**APPLICATION FOR CERTIFICATE OF APPROPRIATENESS  
DESIGN REVIEW  
CITY OF GAHANNA PLANNING COMMISSION**

# FAVAZZO AUTO WAREHOUSE

# New Private Auto Warehouse FAVAZZO AUTO WAREHOUSE

**PLAN REVIEW**

**SITE PLAN**  
SCALE: 1" = 20'-0"

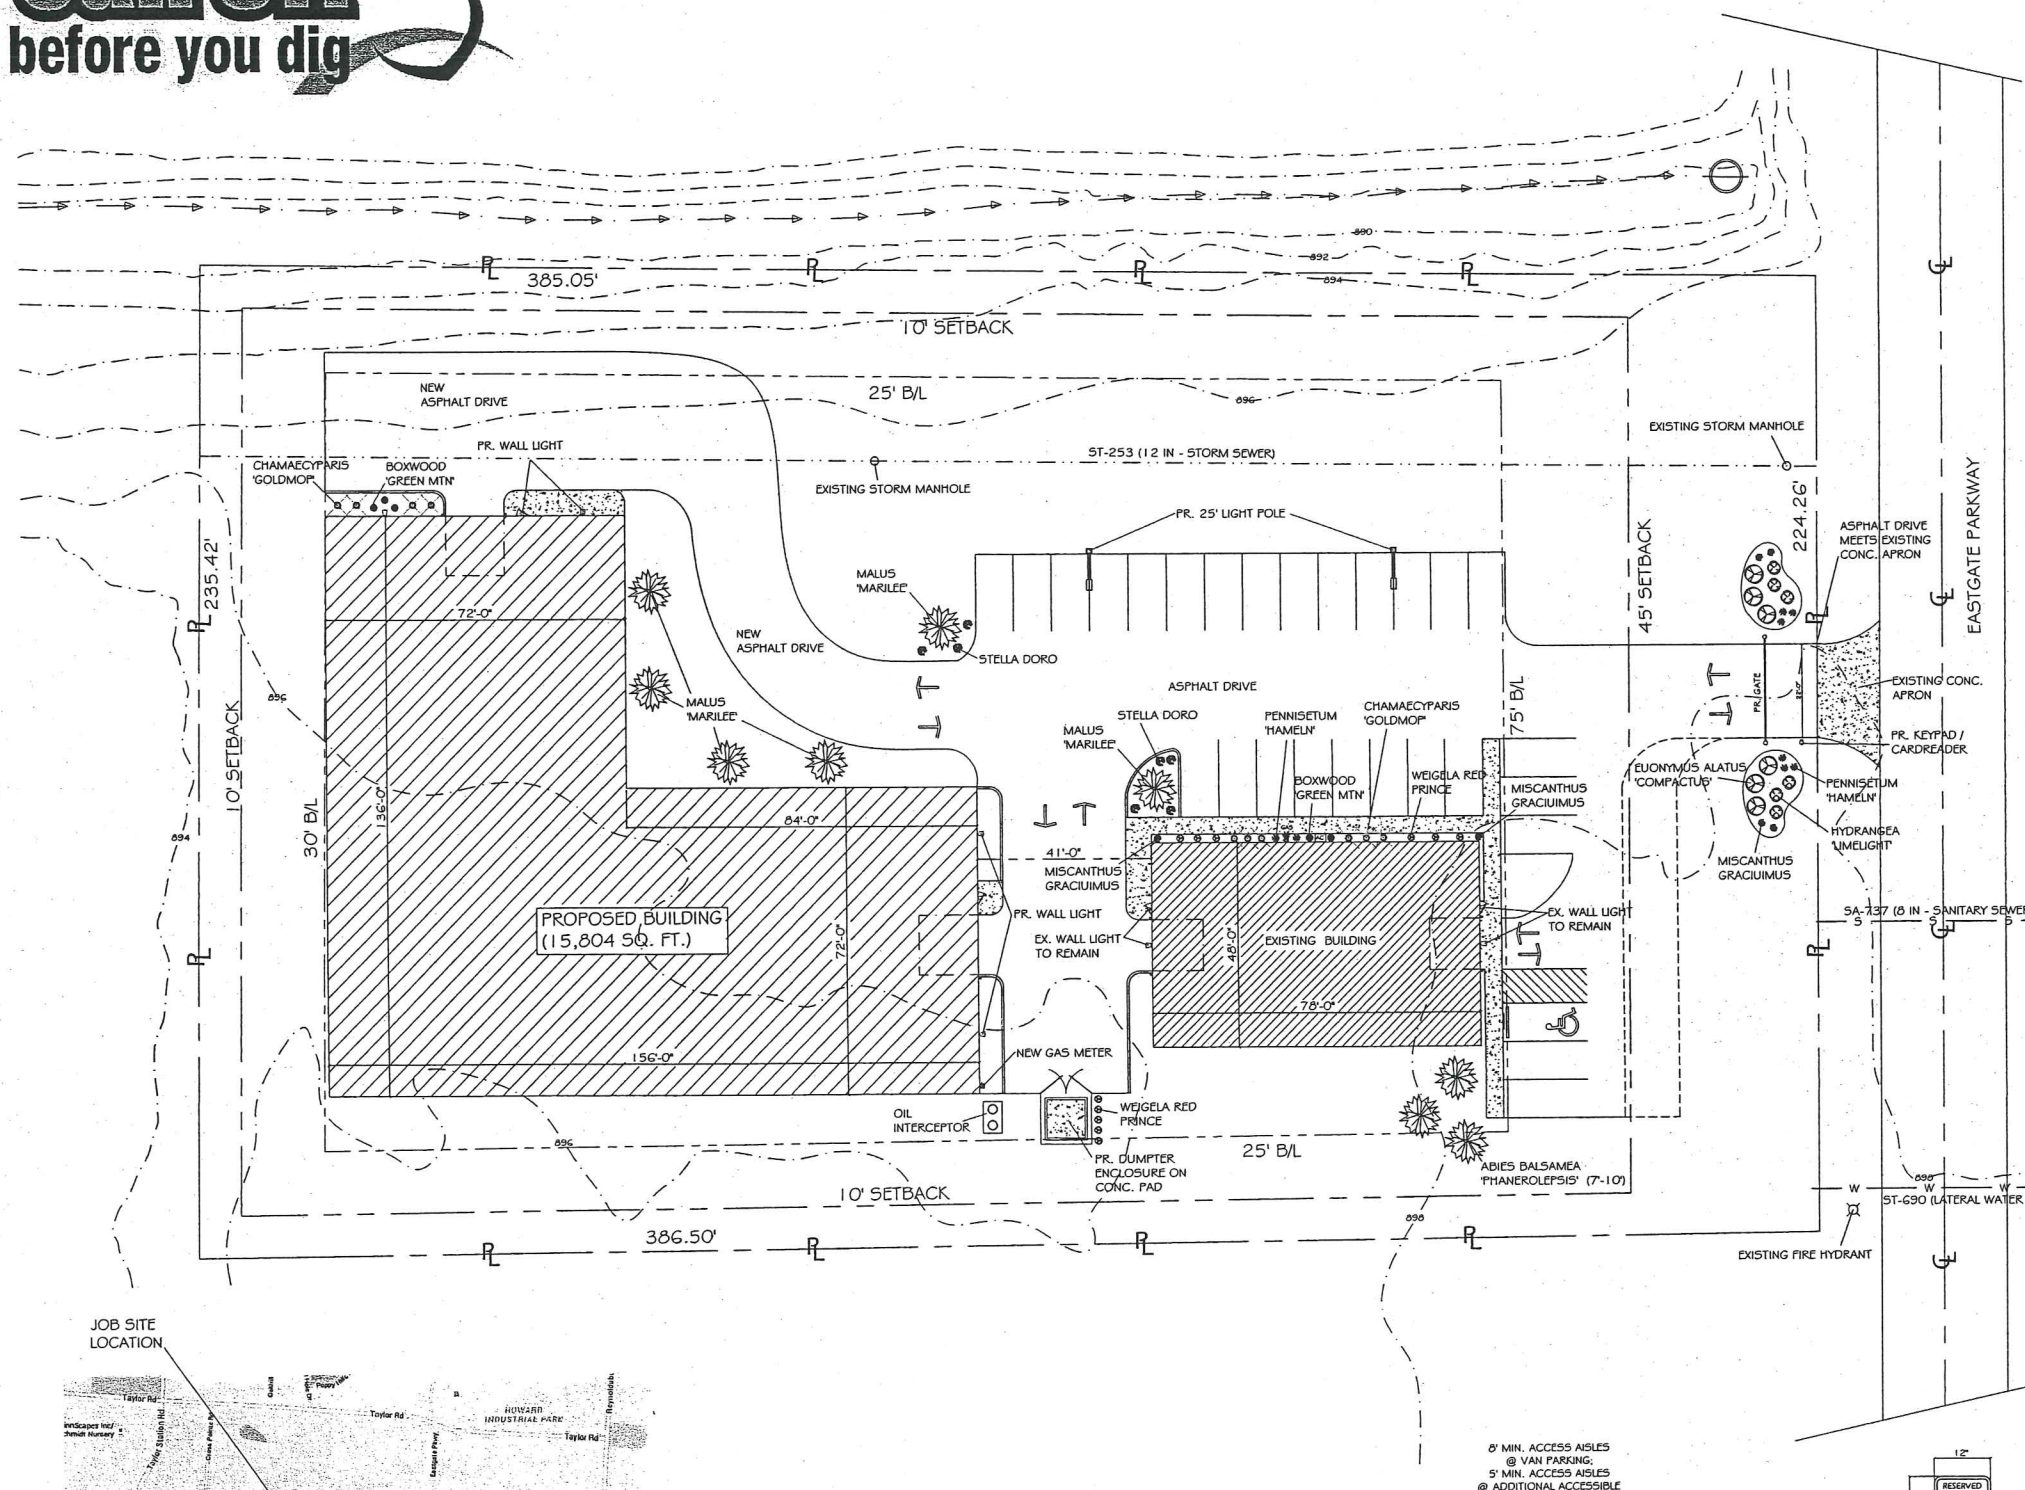
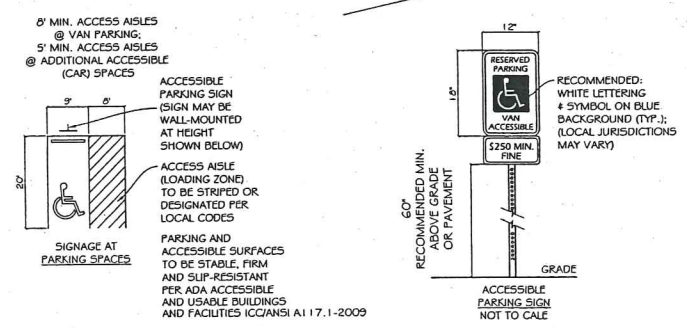
1. The current curb cut on Eastgate Parkway will be utilized for site access. The owner/developer shall coordinate with the Fire Department to verify whether or not the existing drive width is sufficient for emergency access.

1. Stormwater Management shall be provided in accordance to City Code and the direction of the City Engineer. Regional detention is provided for this parcel via the existing regional detention basins. If the project disturbs more than one acre of earth, water quality will have to be addressed as part of the final engineering plans. The system will be reviewed for conformance to City Code during the final engineering plan review.
2. Erosion and Sedimentation control measures shall be provided per City Code 1195 and meet Franklin Soil and Water Conservation District requirements.

1. The site is currently tied into sanitary sewer, however, if revisions to the existing sanitary service are made, they shall be detailed in the final engineering plans for review and comment.

1. The property is currently served by an existing  $\frac{3}{4}$ " inch domestic service. If revisions to the existing water service are made, they shall be detailed in the final engineering plans for review and comment.
2. Verify with the Fire Department to see if there is the need for additional fire hydrants.
